Access Compliance Report Public Rights-of-Way (Curb Ramps)

Main Street: BRADCLIFF_DR Cross Street: COVENTRY_PL Location: E

ADA ID: RPRK211013110521 Ramp Type: Type 1 - Perpendicular Initial Pass/Fail: Fail Overall Compliance: No Severity Score: 16

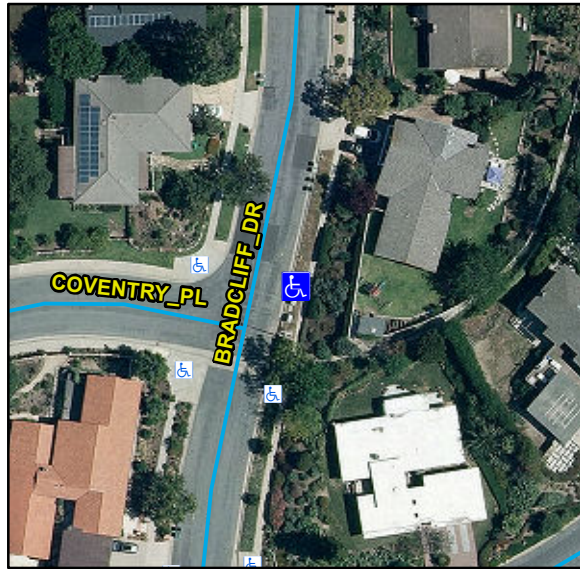
Compliance	Description	Data	Compliance	Description	Data
N/A	Ramp Length (in)	88	N/A	Flare Type LT	
Yes	Ramp Width (in)	48			N/A
No	Ramp Run Slope (%)	11.2	N/A	Flare Slope LT (%)	N/A
No	Ramp Cross Slope (%)	3.3	N/A	Flare Traversable LT	N/A
N/A	Landing Present	N/A	N/A	Flare Type RT	
N/A	Landing Length (in)	N/A			N/A
N/A	Landing Width (in)	N/A	N/A	Flare Slope RT (%)	N/A
N/A	Landing Run Slope (%)	N/A	N/A	Flare Traversable RT	N/A
N/A	Landing Cross Slope (%)	N/A	N/A	DWS Provided	N/A
N/A	Landing Movement Obstructed?	N/A	N/A	DWS Contrast	N/A
	Landing Movement Type	N/A	N/A	DWS Length (in)	N/A
N/A	Landing Shared	N/A	N/A	DWS Full Width	N/A
N/A	Clear Space	N/A	N/A	DWS Offset Left (in)	N/A
N/A	Clear Space To Crosswalk (in)	N/A	N/A	DWS Offset Right (in)	N/A
N/A	Marked Crosswalk 1	No	N/A	Marked Crosswalk 2	N/A
	Crossing 1 Direction	W		Crossing 2 Direction	N/A
	Marked Crosswalk 1 Width (in)	N/A		Marked Crosswalk 2 Width (in)	N/A

N/A	Ramp Inside Crosswalk 1	N/A	Yes	Ramp Inside Crosswalk 2	N/A
	Crossing 1 Slope (%)	5.7		Crossing 2 Slope (%)	N/A
	Crossing 1 Cross Slope (%)	2.9		Crossing 2 Cross Slope (%)	N/A
N/A	Gutter Ponding	N/A	N/A	Curb Slope	3.1
Yes	Gutter Lip Height (in)	0		Road Run Slope (%)	N/A
N/A	Gutter Run Slope (%)	N/A		Road Cross Slope (%)	N/A
N/A	Gutter Cross Slope (%)	N/A			
Yes	Overall Surface Condition: Acceptable		No	Perp Joint Present	No
	Cross Gutter Present?	No		Spandrel Present?	No
	Replace Cross Gutter?	N/A		Replace Spandrel?	N/A

Remove & Replace Entire Ramp.

R204.3, R304.2.2, R304.5.3, STD 1115
